**City of Tacoma
TACOMA VENUE AND EVENTS
TACOMA DOME FENCING PROJECT
RFB Specification No. PF20-0334F**

QUESTIONS and ANSWERS

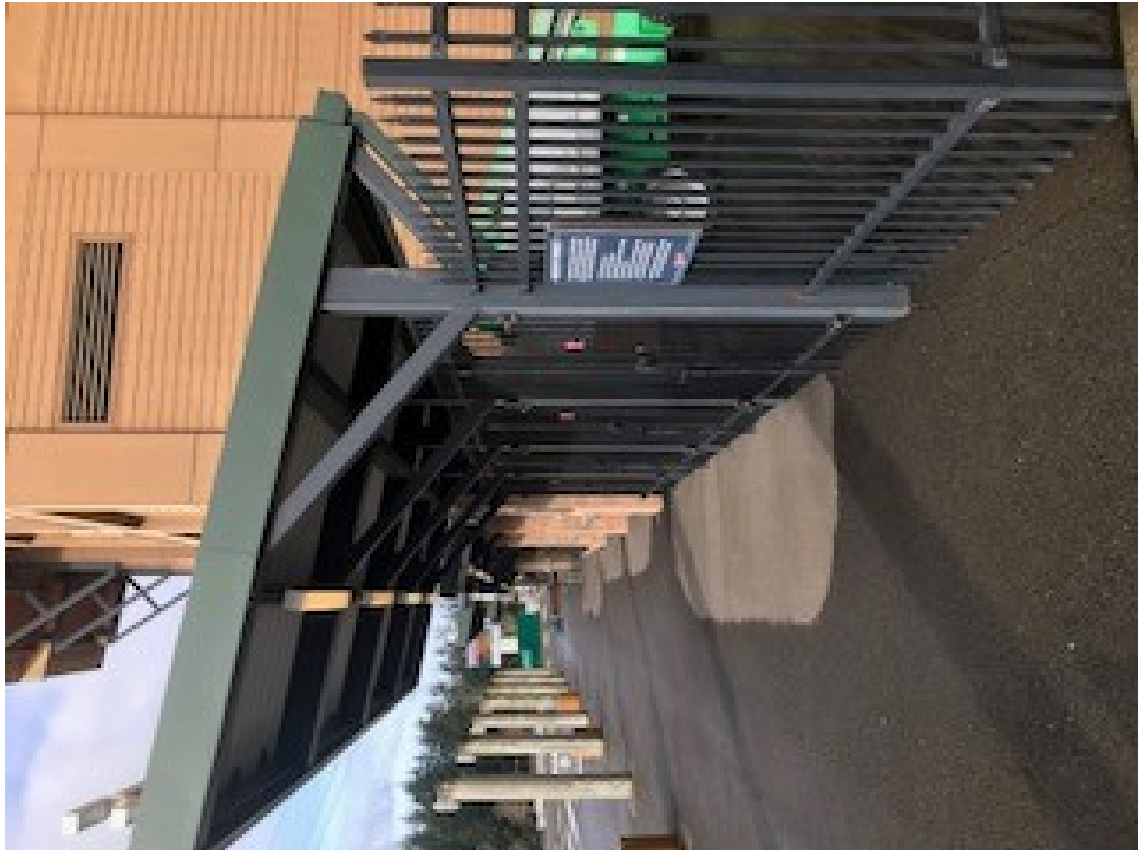
Question 4: On the single gates are there any details for the overhead coverings?

Answer 4: There are no specific requirements other than those included in the already provided addendum. Please see below photo as an example of an acceptable solution. Bidders should submit their individual solution plan as part of their proposal.
